****CORRECTED** NOTICE OF DISPOSITION**

**MINOR REPLAT, TENTATIVE SUBDIVISION PLAT MODIFICATION, AND MINOR
MODIFICATION TO AN APPROVED DETAILED DEVELOPMENT PLAN**

ORDER NO. 2005-139a

CASE: Stoneybrook Phase III
**Minor Replat, Tentative Subdivision Plat Modification, Minor Planned
Development Modification (MRP05-00008, SUB05-00003, PLD05-
00016)**

Project No. 0236
 Sheet No. EX-15
 Generated: 2002 0

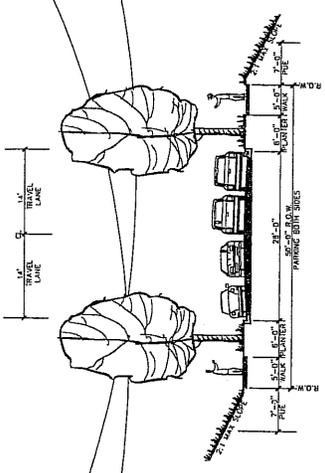
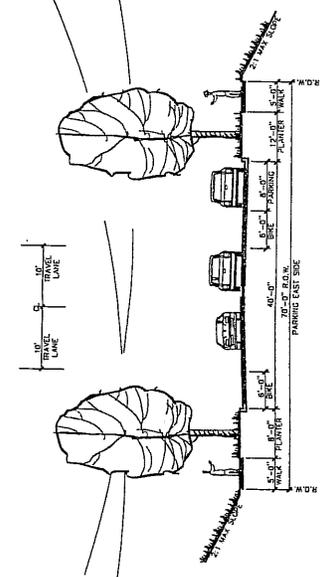
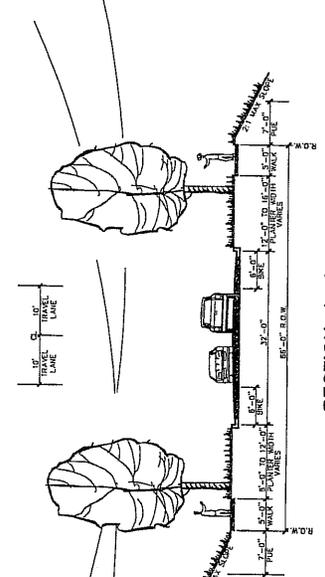
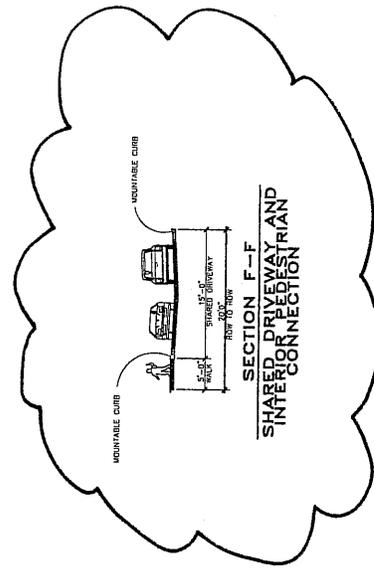
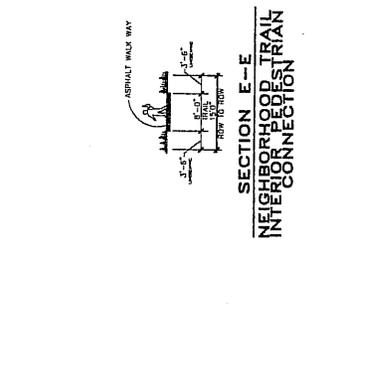
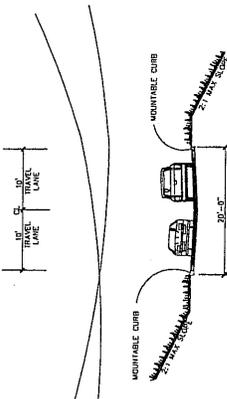
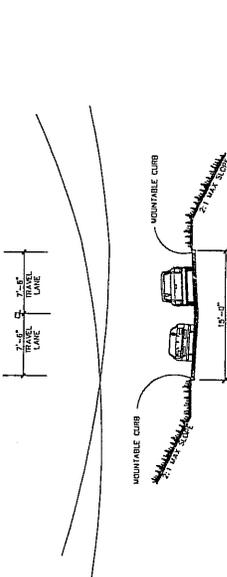
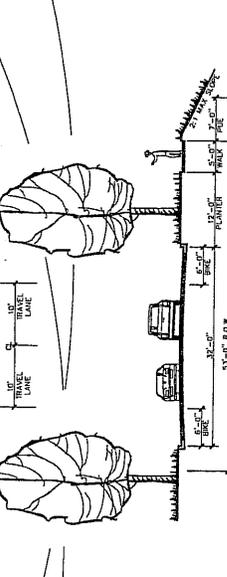
After this decision was issued, further review of application materials submitted for the 2003 Detailed Development Plan for Stoneybrook Phase III (PLD03-00004/SUB03-00002) indicated that Tract "H" had already been approved for use as a combined pedestrian and vehicular accessway (**Attachment E**). Therefore, the request made through the Minor Planned Development Modification denied by Order 2005-139 was not necessary. As a result, the decision issued through Order 2005-139 is hereby clarified to re-establish the approval for using Tract "H" as a combined pedestrian and vehicular accessway, as shown in **Attachment E**.

The requested alteration in use of Tract "H" does result in a decrease of common open space. A total of 1.41 acres (61,419 square feet) of open space was provided in tracts through the approved Detailed Development Plan. The width of Tract "H" has increased through this request from 15 feet to 20 feet, which increases the total area contained in tracts to 61,644 square feet. However, the introduction of a vehicular accessway within Tract "H" decreases the amount of common open space within the Tract by 675 square feet, which equates to a 1 percent decrease in total common open space for the development. Therefore, the request falls below this threshold.

Based on the review of the current application, Tract "H" will contain a 5-foot wide sidewalk and a 15-foot wide vehicular accessway. No information is provided in the applicant's narrative as to the pavement width of the proposed driveway, but it would presumably be wide enough to provide for two-way travel between SW Hollyhock Circle and Lots 54 and 55. The City's minimum driveway width for a single access drive serving two dwelling units is 18 feet. Therefore, the ability to provide the pedestrian amenities noted above is not possible through the proposed Modification, because the Tract is not wide enough to contain a path of reduced width and the access drive, and allow remainder area for buffer landscaping. This collectively results in the elimination of Tract "H" as a functional pedestrian amenity, as approved through PLD03-00004, and a corresponding 25 percent decrease in the total number of tracts approved within the

Given the above, this aspect of the request exceeds the threshold noted above for a Minor Planned Development Modification.

2. **Consistency with Plans** – Development shall comply with the narrative and plans in the applicant's proposal as identified in **Attachments C and E**, except as expressly modified by this approval.
